CONSTRUCTION QUALITY ASSURANCE CERTIFICATION REPORT

CELL 1 of PHASE 2A CONSTRUCTION
BROWNFIELD ROAD C&D LANDFILL
NCDENR PERMIT # 92-31

RE: Construction Quality Assurance Certification Report
WCA Waste Corporation Brownfield Road Landfill, Cell 1 of Phase 2 A Expansion
NC DENR Permit #92-31
Wake County, North Carolina
JEI Project 824.1102.21, Task 01

FIGURE A - Facility Layout
(Waste Boundaries are Approximate)

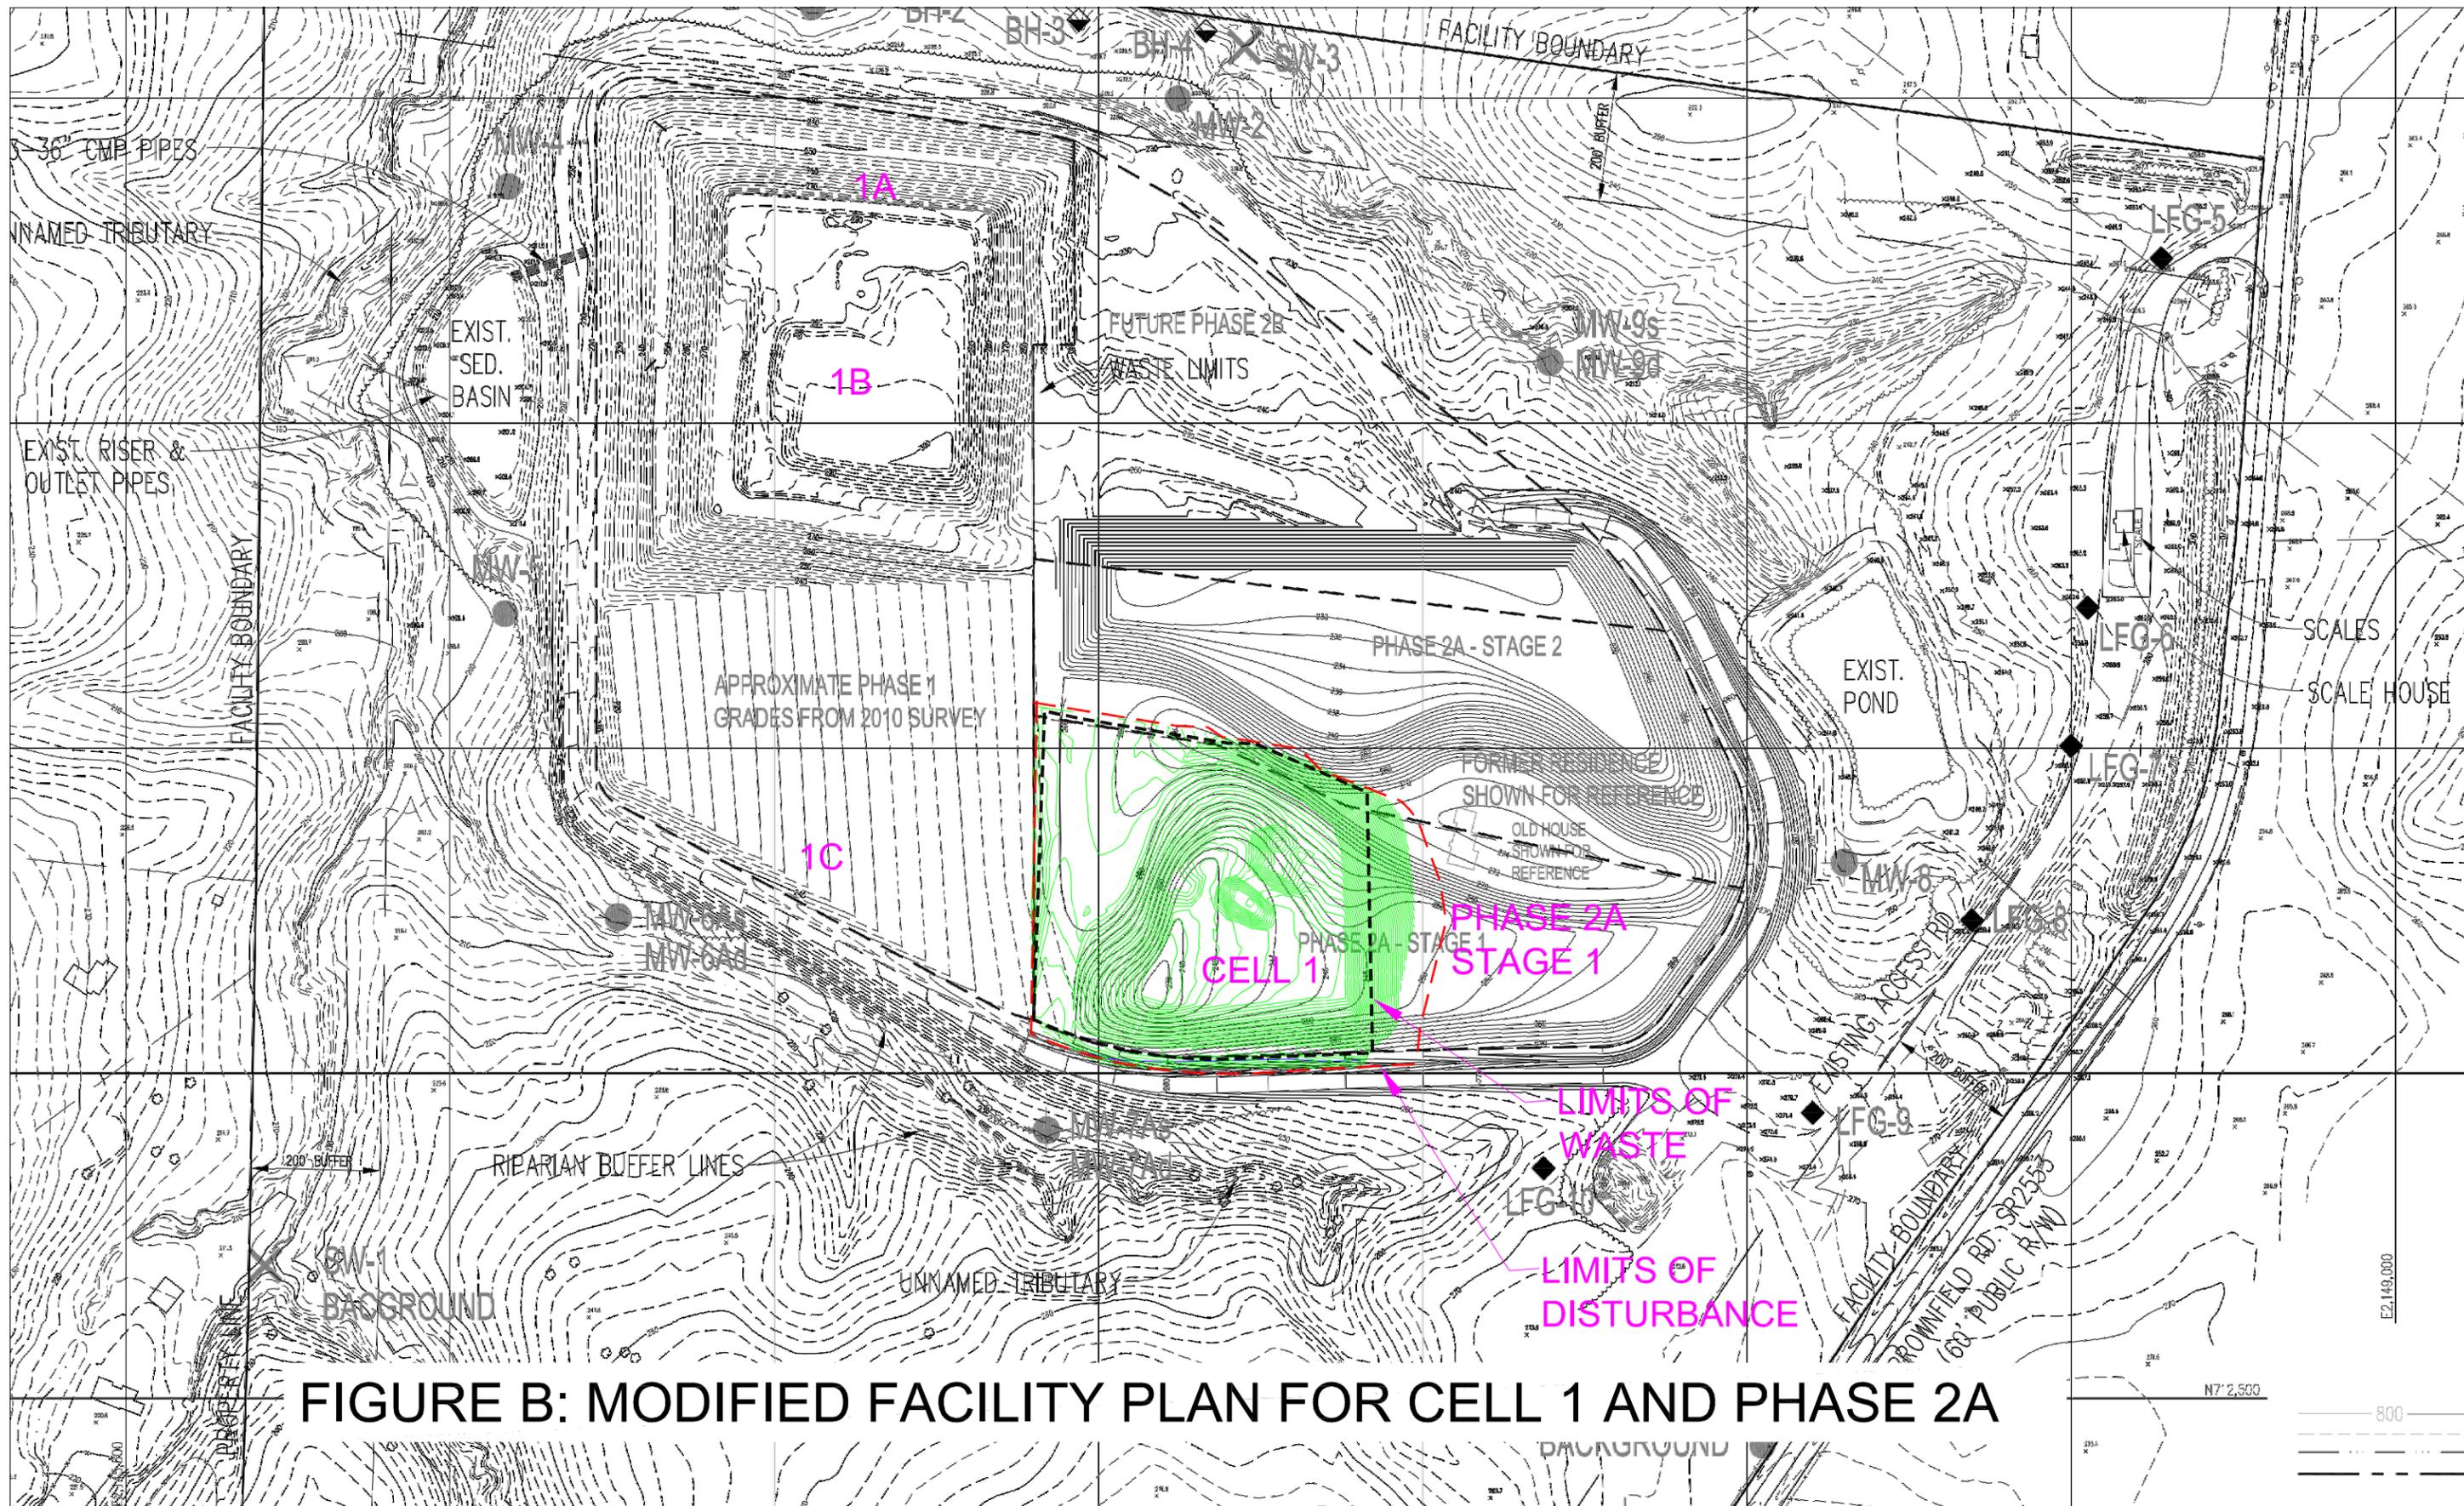
2. Since only a portion of Phase 2A was constructed, provide a drawing showing the boundaries of Cell 1 and the other planned cells in Phase 2A, making up the total boundary of Phase 2A. Also provide the acreage of the cells and the approximate volume of each cell.

1. Figure B is confusing in that the waste footprint shown is not accurate for Phase 2A and 2B; the eastern boundary should extend further east. Please label Cell 1 as-built on a drawing that also shows the boundary for Phase 2A.

1. Figure B is confusing in that the waste footprint shown is not accurate for Phase 2A and 2B; the eastern boundary should extend further east. Please label Cell 1 as-built on a drawing that also shows the boundary for Phase 2A.

Figure A- Facility Layout; from the permit application and Figure B - Modified Facility Plan for Cell 1 Phase 2A; are included to address requested information. Joyce Engineering does not have permit drawings in our possession, thus the Figures A and B are included to clarify the Phase 1 and 2 boundaries, and the constructed Cell 1 of Phase 2A.

Figure B has been revised to reflect permitted waste limits.
